MEMORANDUM FOR: RECORD

February 13, 2014

SUBJECT: DETERMINATION REGARDING THE SUITABILITY OF PROPOSED DREDGED MATERIAL FROM LONGVIEW FIBRE PAPER AND PACKAGING DOING BUSINESS AS KAPSTONE KRAFT PAPER CORPORATION, COWLITZ COUNTY, WA EVALUATED UNDER SECTION 404 OF THE CLEAN WATER ACT FOR FLOW-LANE DISPOSAL IN THE COLUMBIA RIVER OR FOR BENEFICIAL USE.

Figure 2.

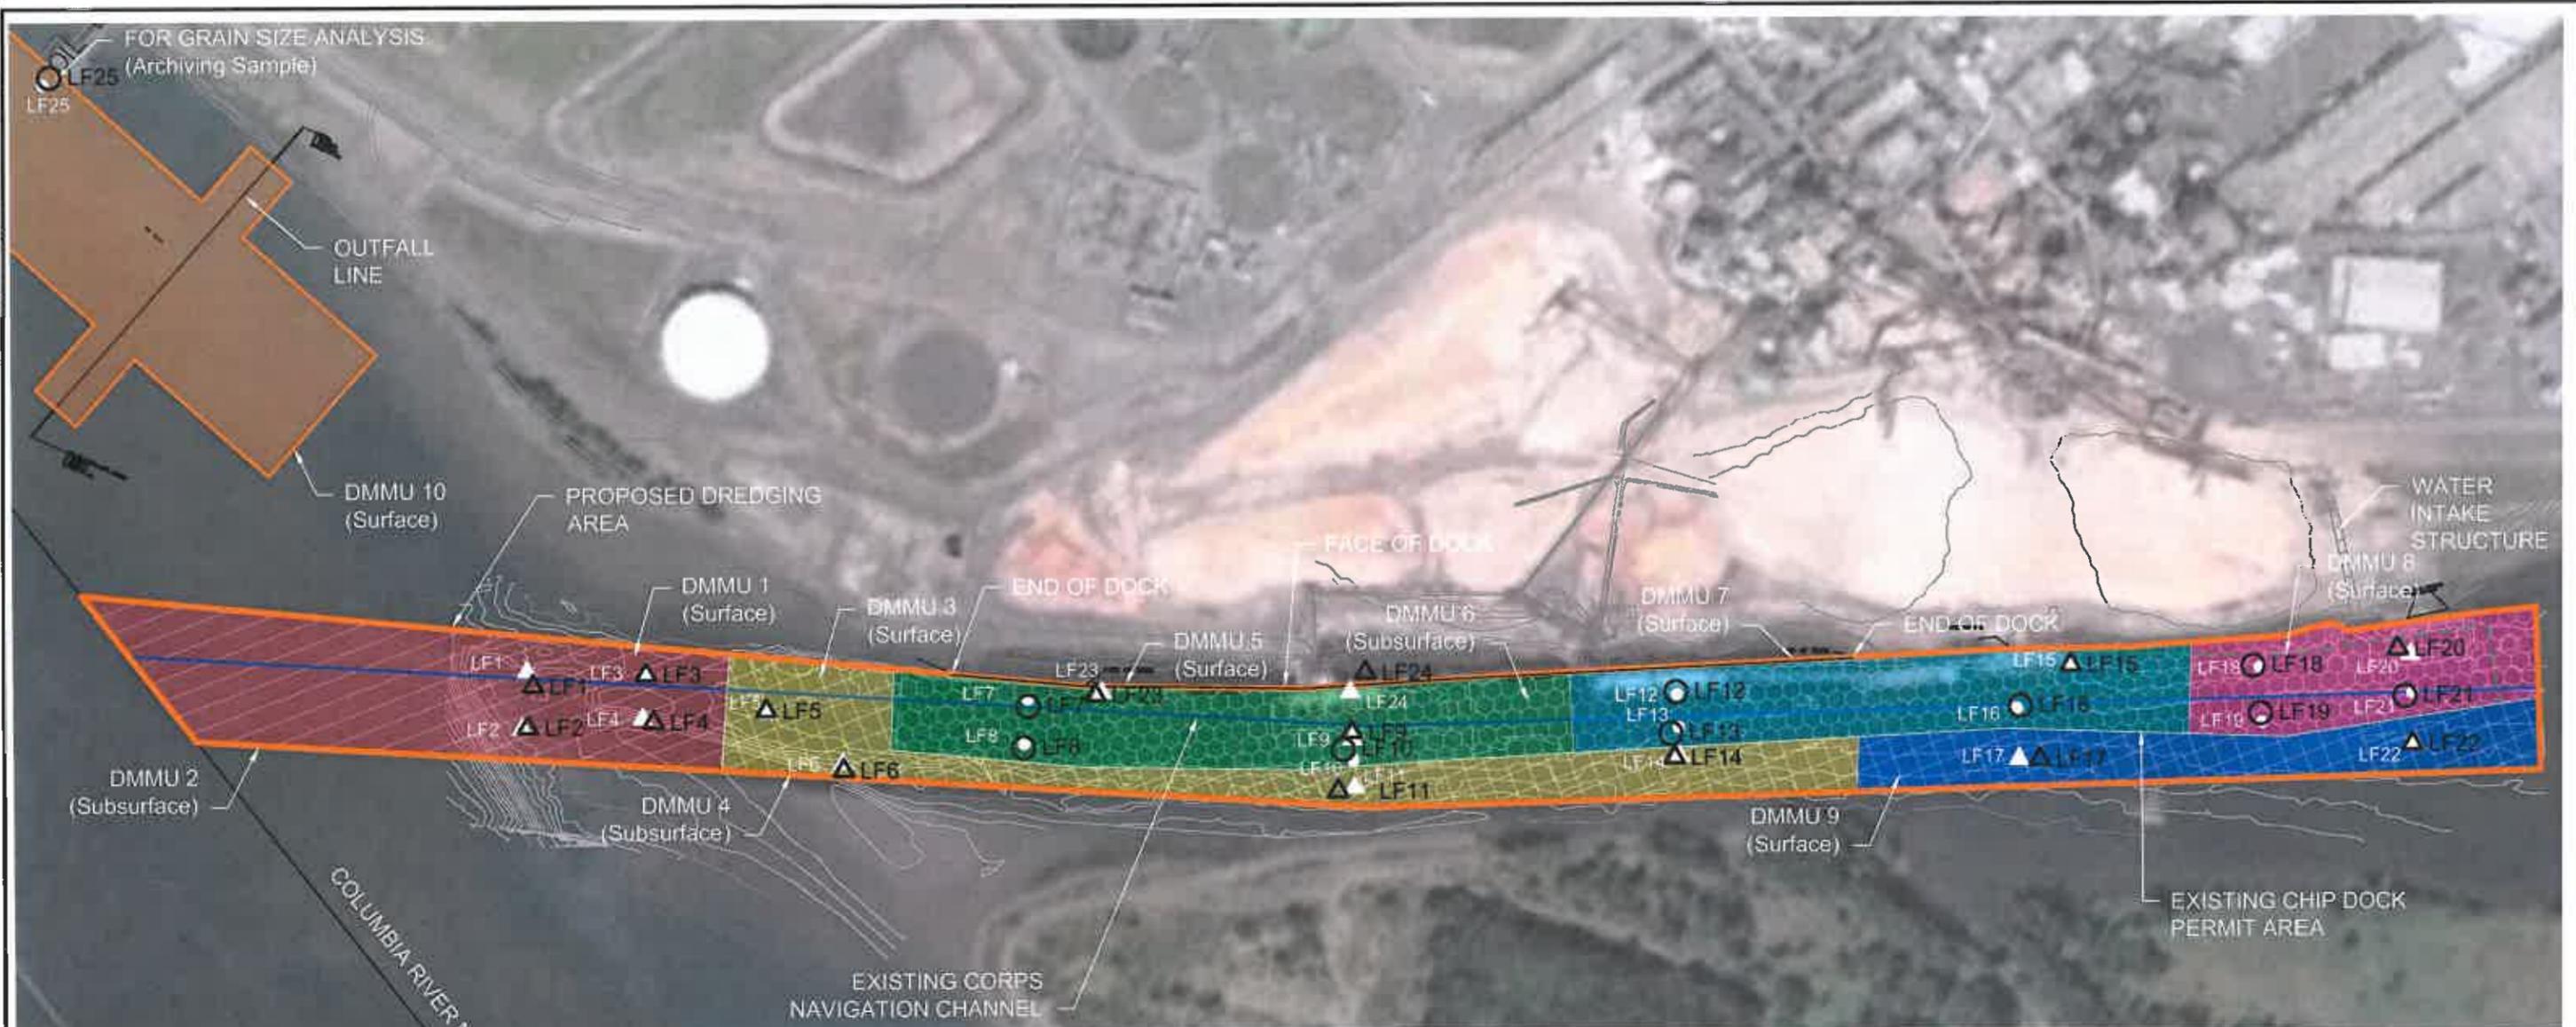
This project was divided into 9 DMMUs in the Old Cowlitz River Channel area; with six surface DMMUs and three subsurface DMMUs, see Figure 2 for DMMU configuration. DMMUs 5, 7 and 8 are part of the area previously dredged under a permit to Longview Fibre to a depth of -12 ft CRD, so these three surface DMMUs were characterized to a depth of -12 ft CRD. DMMU 6, the subsurface DMMU underneath DMMUs 5, 7 and 8, was characterized from -12 to -14 ft CRD. DMMUs 1, 3 and 9 were previously dredged as part of the Portland District Army Corps of Engineers navigational dredging, and were only characterized to -10 ft CRD. Therefore these three surface DMMUs were characterized to -10 ft CRD, and the two subsurface DMMUs (DMMUs 2 and 4) underneath were characterized from -10 to -14 ft CRD.

Multiple coring attempts were required at each sample location due to bent core tubes and core refusal on rock, logs or other debris at less than the required sampling depth. As a result, coring stations were moved until an acceptable core was retrieved. Several locations required more than three attempts to retrieve an acceptable core. However, the expected mudline elevations at the station locations were not adjusted for movement of the station locations.

Coordinates of the actual sampling locations were recorded to 4 decimal places (ten thousandths of a decimal degree) instead of 5 decimal places as required in the SAP. The horizontal accuracy of coordinates recorded to 4 decimal places is approximately 36 ft latitude and 25 ft longitude.

At the time of sampling, the mudline elevations relative to Columbia River Datum (CRD) were not calculated. Instead, it was assumed that the mudline elevation at the actual sampling location was the same as that calculated during preparation of the SAP for the target sampling locations. This method fails to account for a) uncertainties in horizontal location due to imprecise coordinates, b) movement of sampling location due to sampling difficulties, and c) changes in the mudline elevations due to sediment deposition or scouring between the time the bathymetric survey elevations were collected and sampling. As a result, 27 of the 40 samples (or 17 of the 25 cores) collected varied from the vertical extent of the dredge prism by more than 1 foot.

Clearly, these discrepancies seriously compromise the integrity of this characterization. As a result, the DMMP agencies expended unusual amounts of time attempting to understand field compositing decisions and then, after-the-fact, determining the actual segments of the cores that were sampled and what they actually represent with respect to the dredge prism.

The DMMP agencies considered all the above information during deliberations on whether the sampling and testing results were representative enough to be used in making a suitability determination for the project. The DMMP agencies determined they would accept the sampling and testing results for this project for the following reasons:

- There was no systematic bias in the vertical deviations from the proposed dredge prism. Some cores under-represented the DMMU and some over-represented the DMMU.
- Chemical results for every single DMMU were either undetected or detected at concentrations well below screening levels.
